City of Santa Fe, New Mexico

memo

2025-010494-HDRB, 206 McKenzie St., Downtown and Eastside Historic District, Contributing, Bradyn Furry, agent for Mindy Hale and FC3 Ltd. Co., owner, requests approval to increase in height by 0'-8 ½" of a previously approved parapet on the McKenzie St. façade which requires an exception to 14-5.2(D)(2)(c) additions are not permitted unless set back 10' from primary façade.

Figure 2. Existing and Proposed North Elevation.

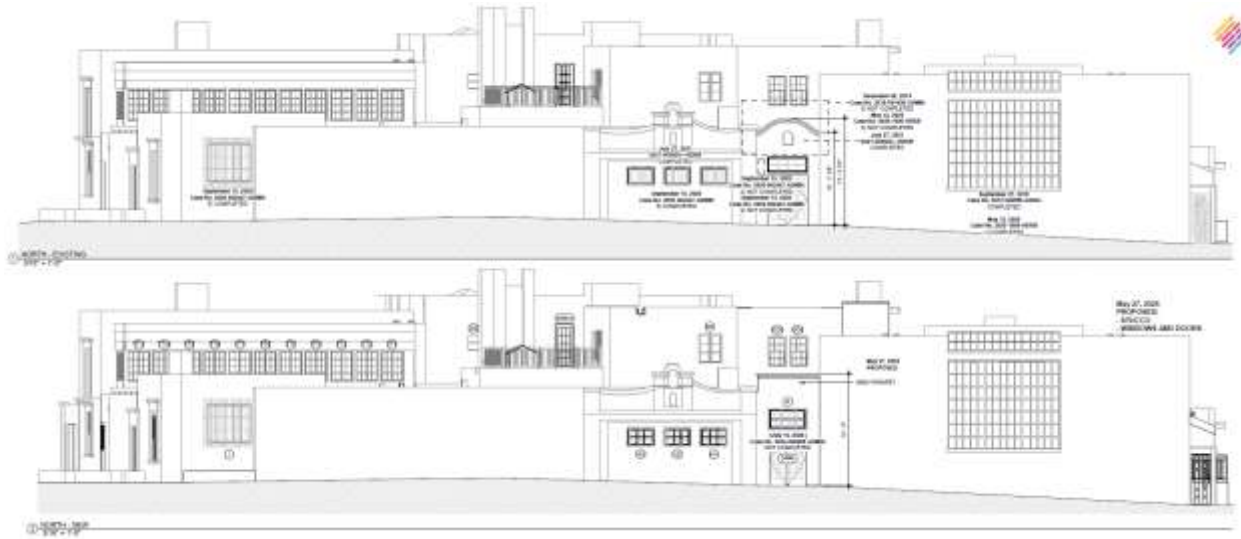
- 1) Change the overall height by 0’-8 ½” from 14’-0 ½” to 14’-9” high from a previously approved parapet on the McKenzie Street north primary facade for which an exception is requested to 14-5.2(D)(2)(c) addition to a primary façade.

Exception to 14-5.2(D)(2)(c) additions are not permitted to primary facades: Staff requests an exception to raise the parapet on the north primary façade 0’-8 ½” higher than the original façade from 14’-0 ½” to 14’-9” high.

Applicant Response: The core design of the proposed addition to the north façade was previously approved by the HDRB and is in keeping with the aesthetic nature of the adjacent portions of the building. The proposed modification only raises the overall height of the parapet.

Applicant Response: Due to work done by a previous contractor, the portion of the wall in question was severely damaged and its structural integrity compromised. The damaged wall needs to be removed and replaced, and the design was modified to more reflect the adjacent facades and the overall aesthetic of the building.

Applicant Response: Because the proposed modification to the previously approved design further separates this portion of the façade from the adjacent building masses, it strengthens the perception that this infill is not trying masquerade as an original piece of the building. Rather, through its increased separation from the adjacent massing's, it further enhances the significance of the original portions of the building.

Staff Response: Staff has evaluated the applicant’s response and finds that this exception criterion has been met. The previously approved design in Case No. 2021-003826-HDRB, had a lower parapet so as to not overwhelm the adjacent distinctive parapet which is part of defining the building’s contributing status. The current request for an exception to raise the parapet is

consistent with what is currently established along the McKenzie Street streetscape and accentuates the historic vocabulary of the development of the structure throughout time.

Staff Response: Staff has evaluated the applicant's response and finds that this exception criterion has been met. The current condition of the adjacent wall (to the west) is compromised by inclement weather. The proposed design does not adversely impact the primary façade as it reflects the overall design of the existing historic parapet.

Staff Response: Staff has evaluated the applicant's response and finds that this exception criterion has been met. The proposed design and raising of the parapet 8 ½" does not adversely impact the primary façade of the structure and maintains the distinctive historic character of the building and the preservation of the McKenzie Street streetscape.
